NTCA – Devon Street West Cycle Route Audit

8 September 2007

1.3 Devon Street West Cycle Audit

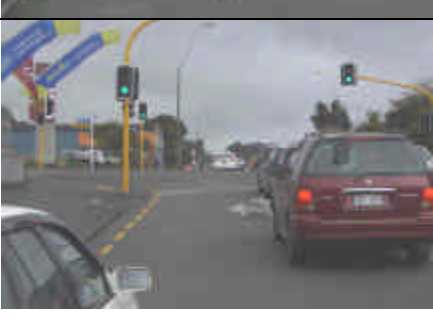
Devon Intermediate and Lorna Street Intersection	This is a crazy area in the mornings with cars stopping, opening doors and pulling out without cycle awareness. There is no cycle lane here. Improved signage and marking would be helpful. I understand that a pedestrian/cyclist underpass is planned at this location and I hope that improving the intersection for schoolchildren includes cyclists' needs on Devon street.	
Approach to Pedestrian Crossing at Belt Road	Note adequate room for cycle lane, if car parking area and lane were narrowed.
